Proposed Amendment to the Antioch-Priest Lake Community Plan: 2003 Update

Metro Planning Commission Meeting of 4/14/05

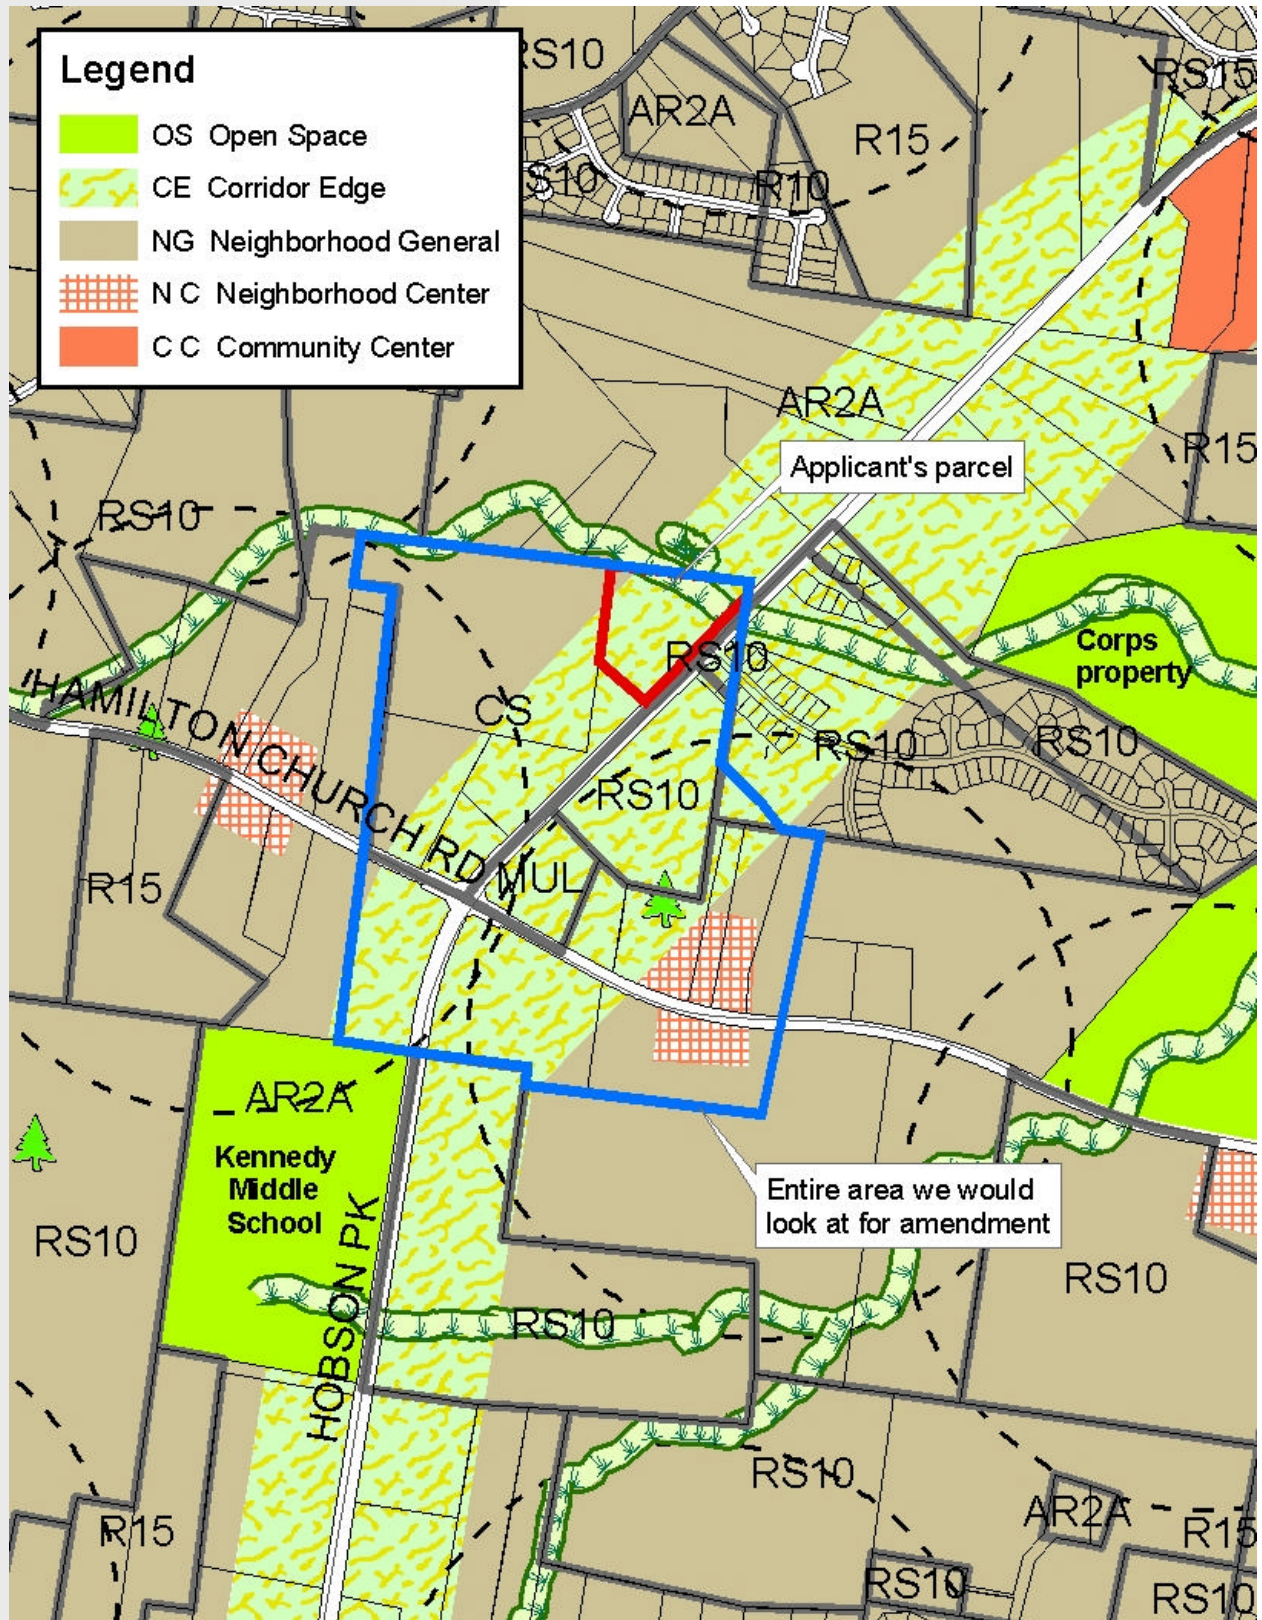
The applicant has requested to add Special Policy Language over the existing CE policy in order to develop a facility that would sell and repair boats and other marine equipment. In reviewing the amendment request, staff expanded the Special Policy area to include several adjacent commercially-zoned (but as of yet undeveloped) properties as well as nearby agricultural properties and residential and commercial developments that would be affected by any new commercial development. This includes the under-construction Windhaven Shores subdivision, directly across Hobson Pike from the applicant’s parcel. The graphic shows both the amendment area requested by

the applicant and the overall amendment area as expanded by staff.

Staff believes that the addition of Special Policy Language to support commercial development would be inappropriate at this time given the still undeveloped nature of the majority of the area. The adjacent properties (one of which is for sale) with commercial (CS) zoning are under multiple ownership and the CS zoning has been in place for many years, with no development action to date. Although it is prudent to acknowledge their existence and eventual development, their currently undeveloped nature reflects a lack of need for additional commercial property in the area. Nearby agriculturally- and residentially-zoned properties are more consistent with the existing policy and natural character of the corridor.
